Appendix A Design Update 01, February 2025

Design Update Request/Notification

FORM A – SUMMARY OF REQUEST/NOTIFICATION			
Project:	The Medworth Energy from Waste Combined Heat and Power Facility Order 2024 Made: 20 February 2024		
Reference:	CP3_R2_DU01		
Originator:	Medworth CHP Limited (the Developer)		
Name:	Tim Marks	Position:	Head of Planning
Issued to:	Cambridgeshire County Council	Date issued:	05/12/2024

EfW CHP Facility Design Update 01

Figure 3.7iv
EfW CHP Facility Elevations

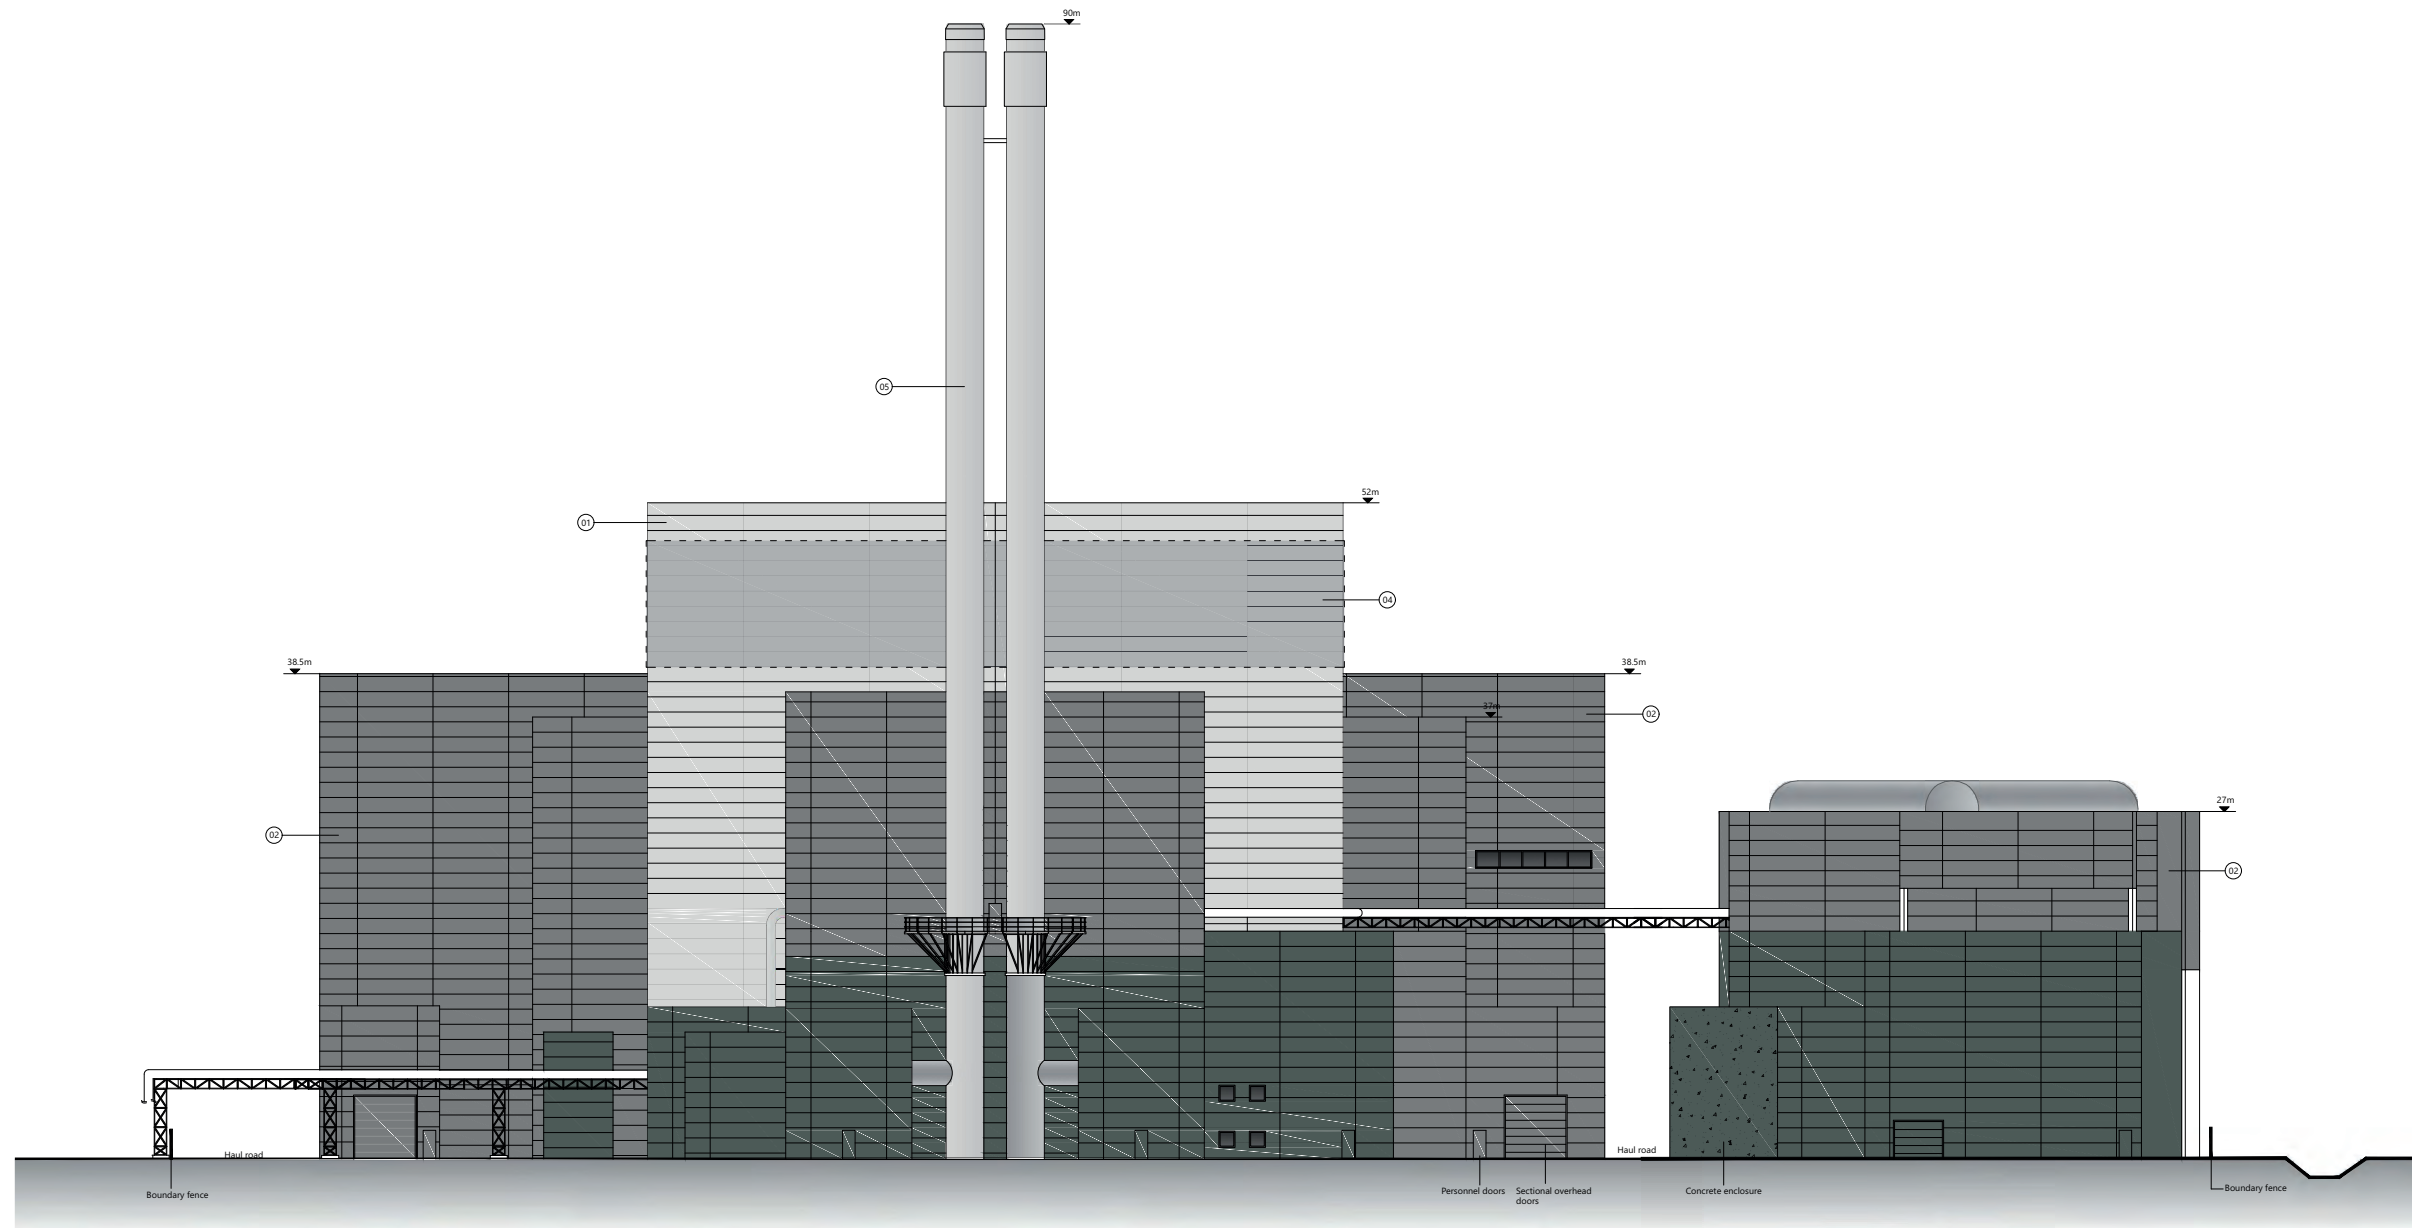
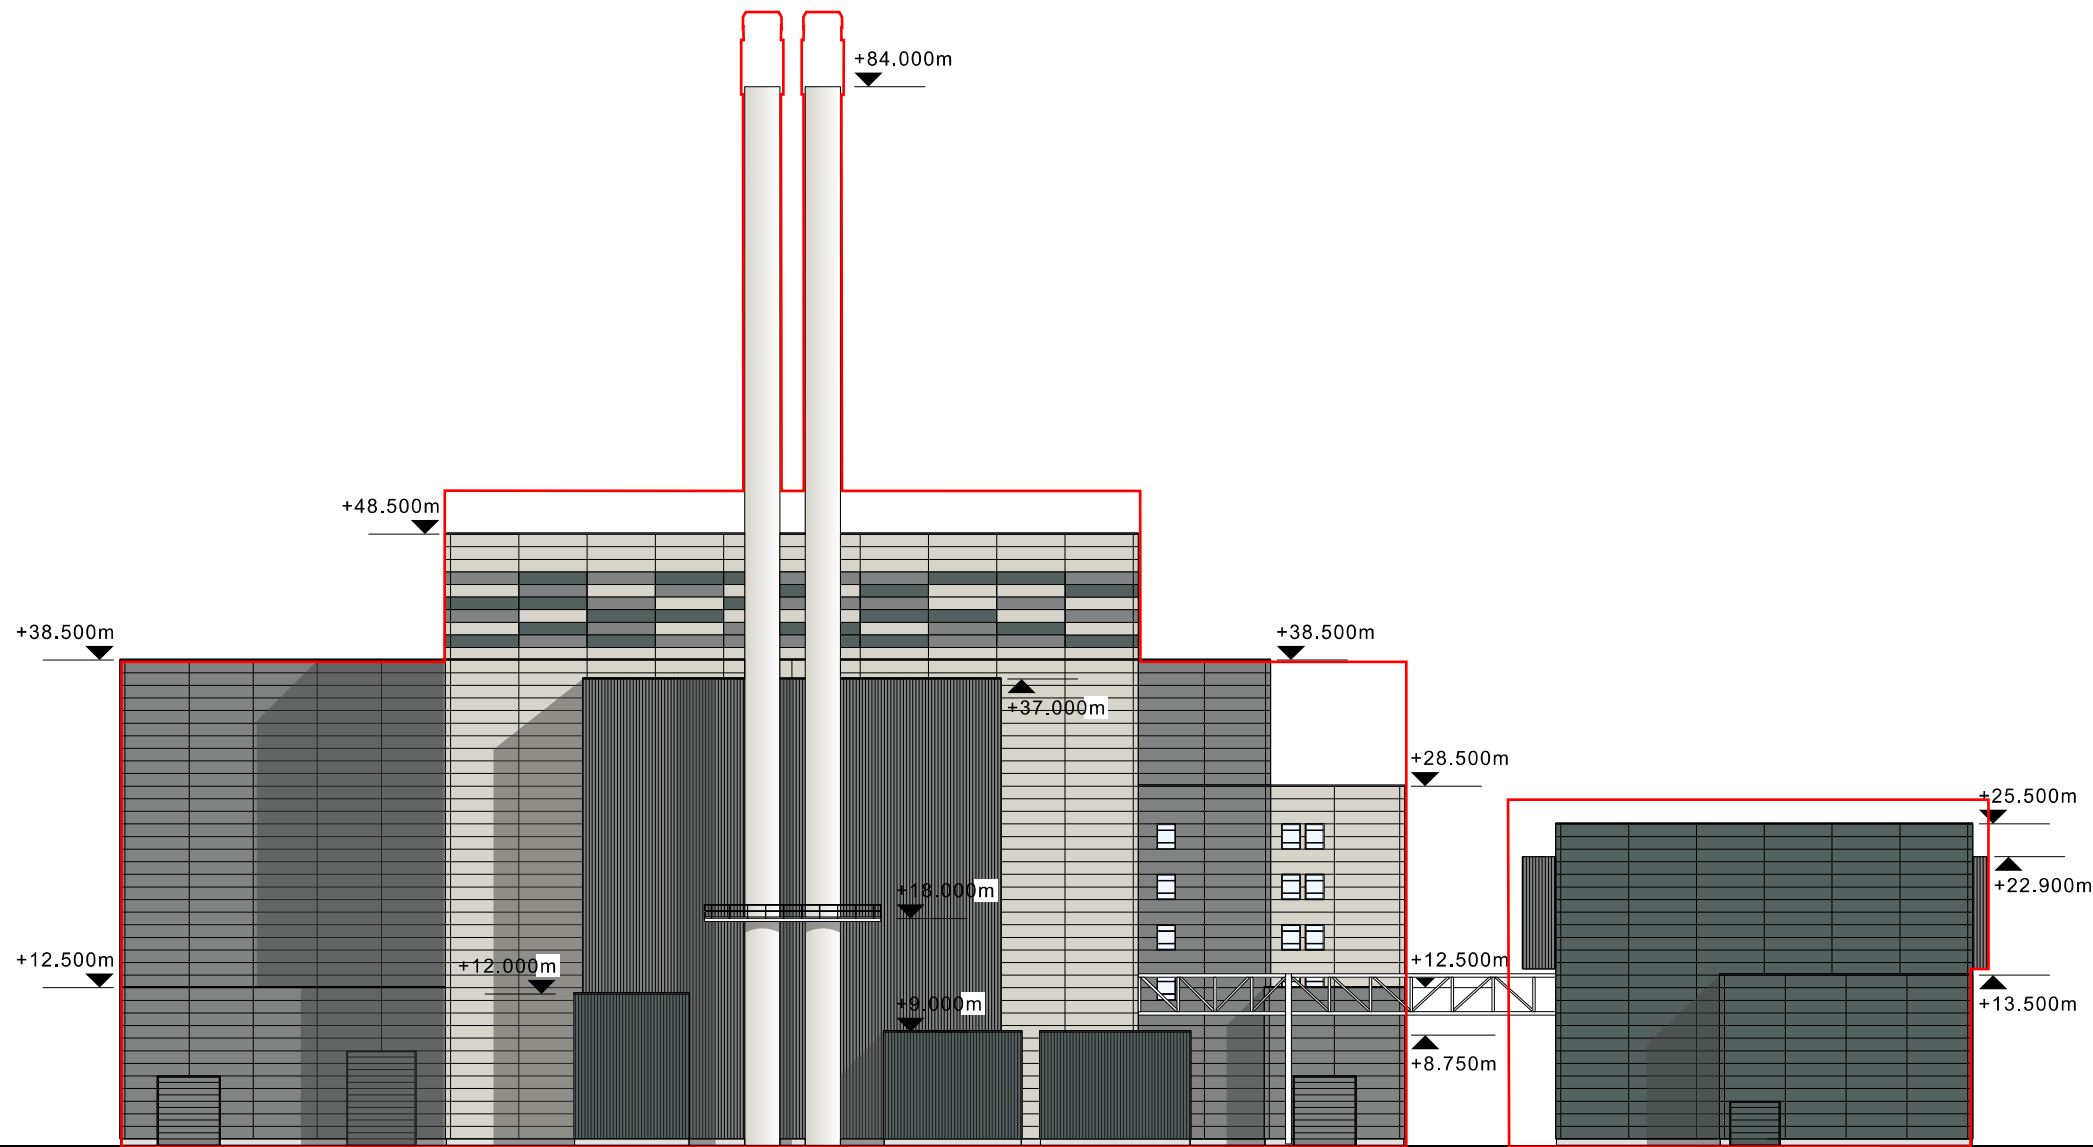
— Outline taken from 3.7_i-iv-3.8-EfW-CHP-FacilityElevations (South Elevation)
